ResourceCo Waste & Resource Management Facility

*State Significant
Development
Modification Assessment
(SSD 7256 MOD 1)*

September 2018

Figure 2 | Location of Enclosure for Baler and Wrapper

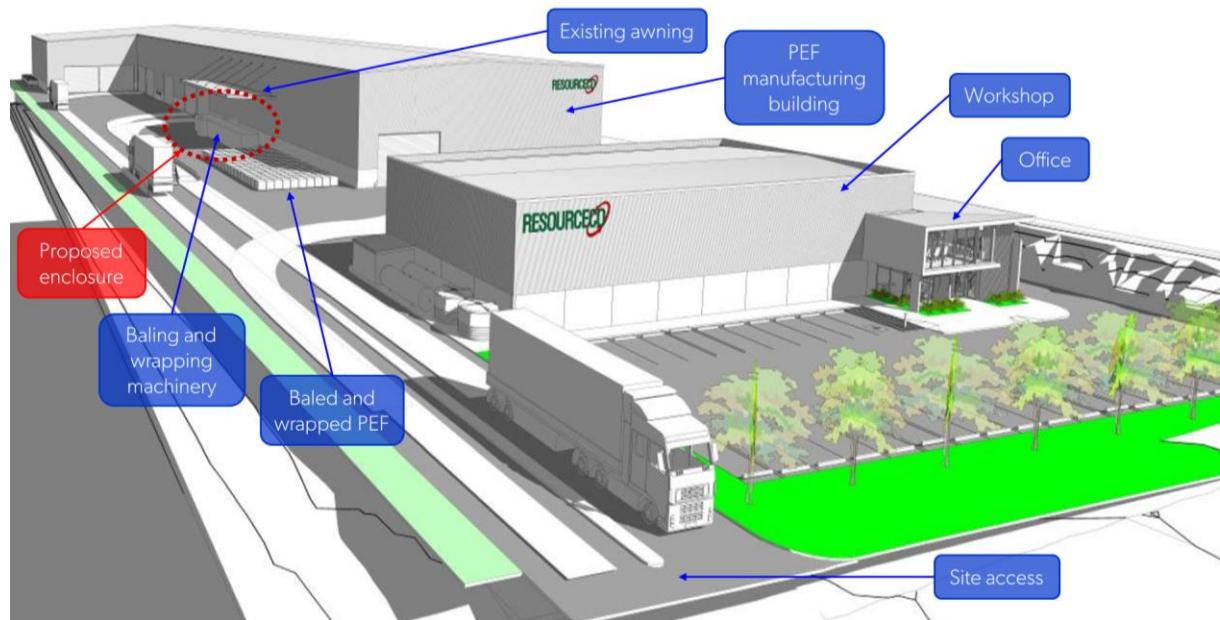
The Applicant has lodged a modification application under section 4.55(1A) of the EP&A Act for the construction of a three-sided structure around the baling and wrapping machinery, within the footprint of the roof awning. The modification application was lodged early 2018, however it was placed on hold for several months at the request of the Applicant. At the time, construction was nearing completion and the Applicant did not want to create complexity during the certification and occupancy stages of the development.

The proposed modification would not result in an increase in the WRMF production capacity or change in the operational processes. The proposed enclosure would be constructed of colorbond cladding on a steel frame and would be connected to the PEF manufacturing building. The existing awning, while independent of the proposed enclosure, would provide weather protection. The cladding would be the same colour (Surfmist) as the colorbond portion of the existing buildings. Baled and wrapped PEF would be removed by a conveyor through a small opening on the southern side of the proposed enclosure and placed in the adjacent baled PEF storage area awaiting transportation off-site. Details of the enclosure structure are provided in **Figure 3**.

Figure 3 | Detail of Enclosure Structure around Baler and Wrapper

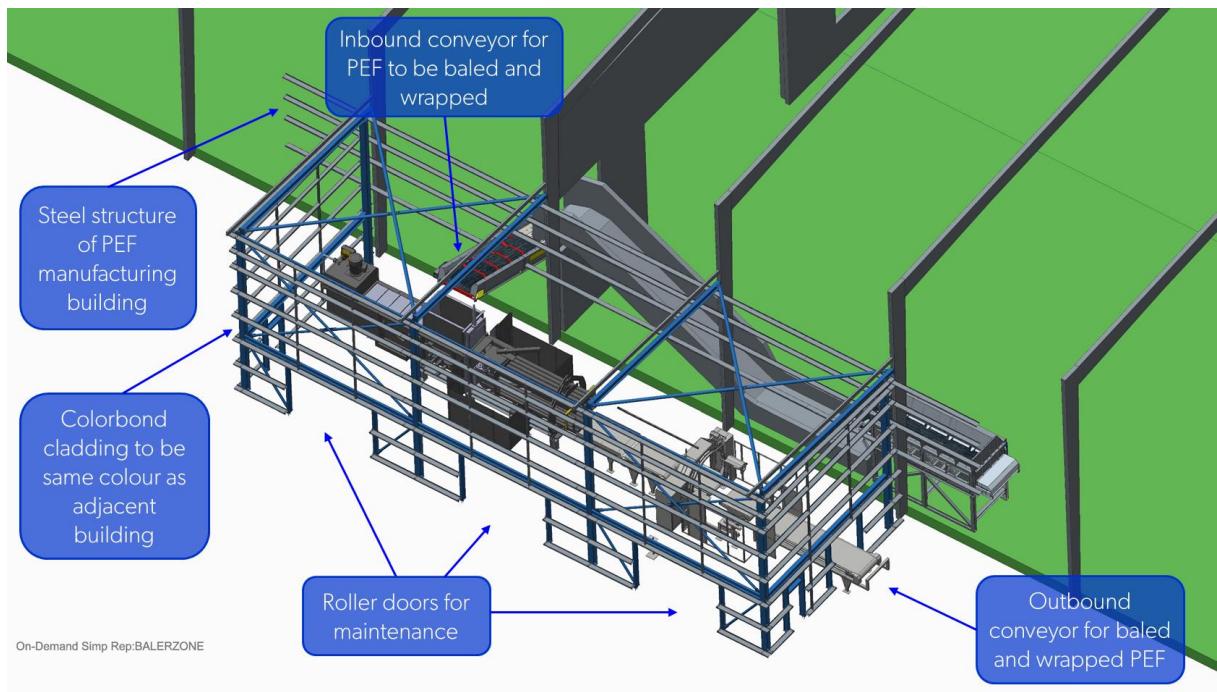
The existing approved roof awning sprinkler system would remain and the baler and wrapper would still be accessible by the existing fire hydrant and hose reels.
